SERVICE BULLETIN

Rudder Centering Fork - Control Stop Replacement

SB-LTUL-CTLS-04

Fig. 5

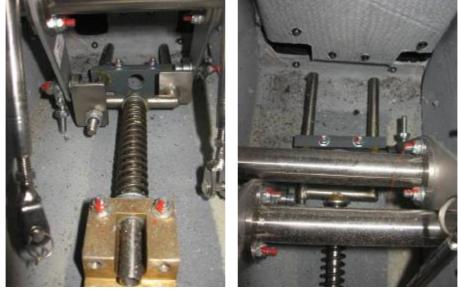
1. The rudder centering fork is not deformed, fork tubes are straight, and fork plates (small square plates shown on the fork, Fig. 5) are not bent or deformed. The correct configuration is shown on Fig. 5, 6;

When deformation is detected at the rudder centering fork, this fork must be exchanged.

Fig. 10

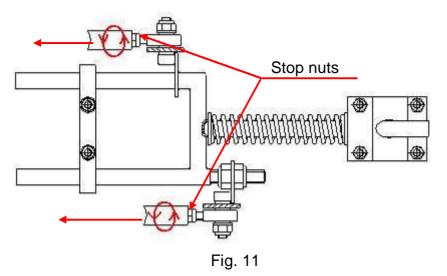
Warning: Keep pedals in neutral position during removal of the rods (Fig. 10). The spring force of the rudder centering fork will push the pedals towards the seats as soon as one of the pushrods is released. It is best done with one person holding the pedals and carefully releasing them after detachment of the pushrods.

Fig. 12

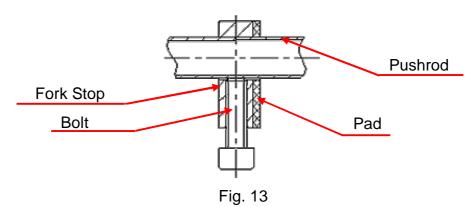
Slide new fork stops with glued rubber pads onto the pushrods (Fig. 12). Fork stops must be located between the welded stop plates (shown in Fig. 7 and below) and the dust covers

at the pass-through hole on the firewall, the rubber pad facing forward, toward the welded stop plate of the engine mount.

Fig. 14

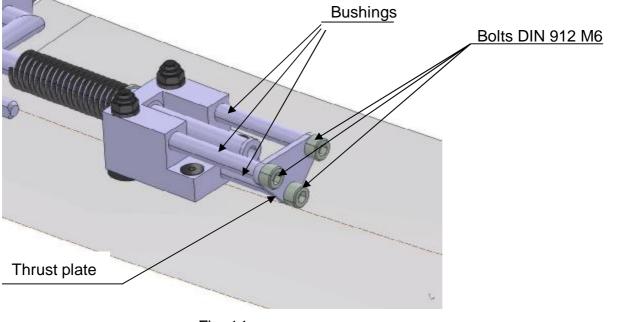
The old fork stop system, that guides the rear end of the rudder centering fork, must be uninstalled when the rudder stop plates are installed. To do this, remove the three bushings, bolts and thrust plate shown in Fig. 14 from the fork mount block. Unscrew three (3) DIN 912 M6 bolts (Fig. 14). Discard these parts.

Fig. 15

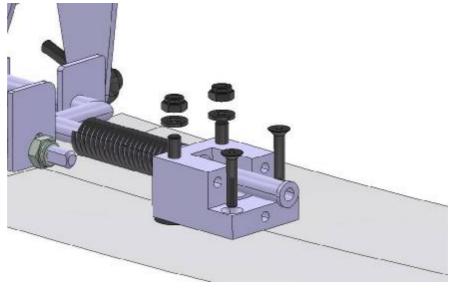
Remove the rear aluminum fork mount block from the lower fuselage skin by unscrewing the 4 bolts as shown in Fig. 15.

Warning: The spring installed to the rudder centering fork provides a pretension to the system and will push the aluminium block to the rear, once all bolts are removed.

Re-attach the aluminium fork mount block with the same 4 bolts. Replace the self locking nuts with new parts. Apply tightening torque: 5.5 Nm.

Fig. 18

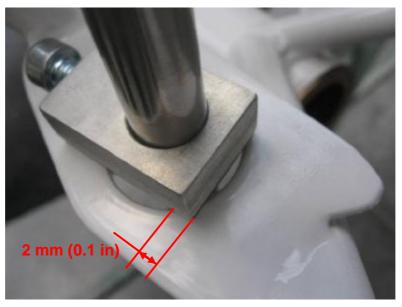
Verify that the overlap of the Aluminium stops with the welded stop plate on the engine mount is at least 2 mm (0.1 in) on the edge of the hole on the welded plate (Fig. 18).

If this is not the case, correct by rotating the Fork Stop. If this does not rectify the issue, contact Flight Design with a picture of the situation and ask for individual guidance.
